Technical BULLETIN

SOME 2014~2016 FZ09E/F/G AND FJ09F/G MODELS Cam Chain Tensioner Noise

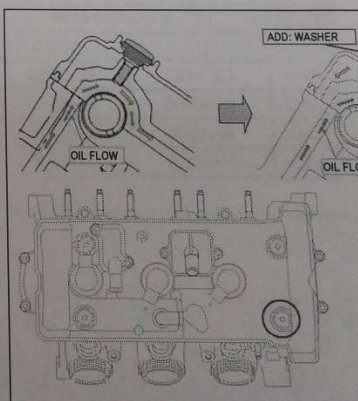
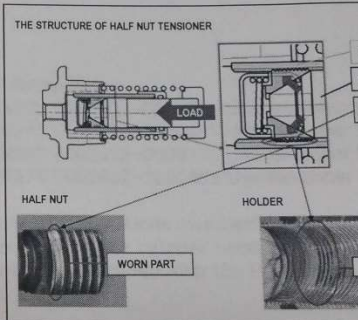
Cause: The threaded portion of the half nut and holder can wear due to insufficient lubrication within the tensioner. This causes reduced friction which allows the half nut to slip. If this occurs, the tensioner cannot maintain constant tension on the cam chain, resulting in noise.

Remedy: The oil passage inside the new tensioner has been modified to increase lubrication within the tensioner body and to the half nut and holder. One head cover bolt has been changed to a new design incorporating an oil passage to feed oil to the tensioner from the camshaft cap.

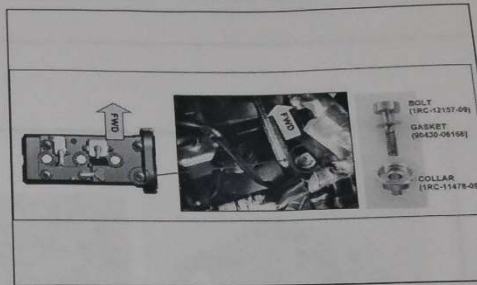
9. Replace the lower right side cylinder head cover bolt (1RC-12157-09-00) with the collar supplied in the kit (90430-06166-00) and torque the bolt to 10Nm (see adjacent photo).

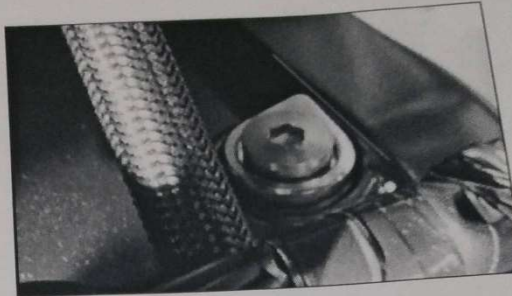
TIP: Degrease the gasket and collar before assembling. Also, before tightening the bolt, press the brim of the collar to the cylinder head cover as shown in the adjacent photo. If the collar is not positioned correctly, the collar will not feed engine oil to the new tensioner.

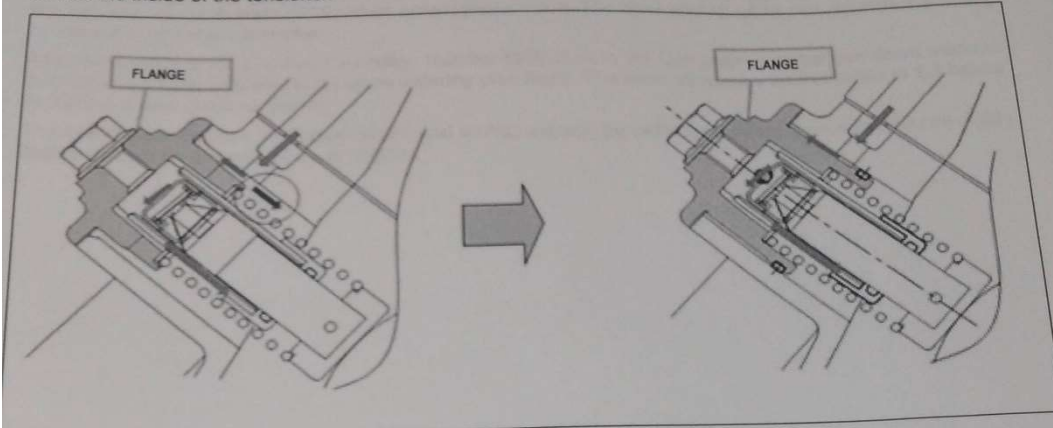
To effectively lubricate the tensioner internally, the tensioner's inner flange size is increased to feed the engine oil into the inside of the tensioner.

Due to a running change in crankcases during Oct.-2015, there are 2 types of tensioner kits available. Order the appropriate tensioner kit for the unit to avoid fitment issues.
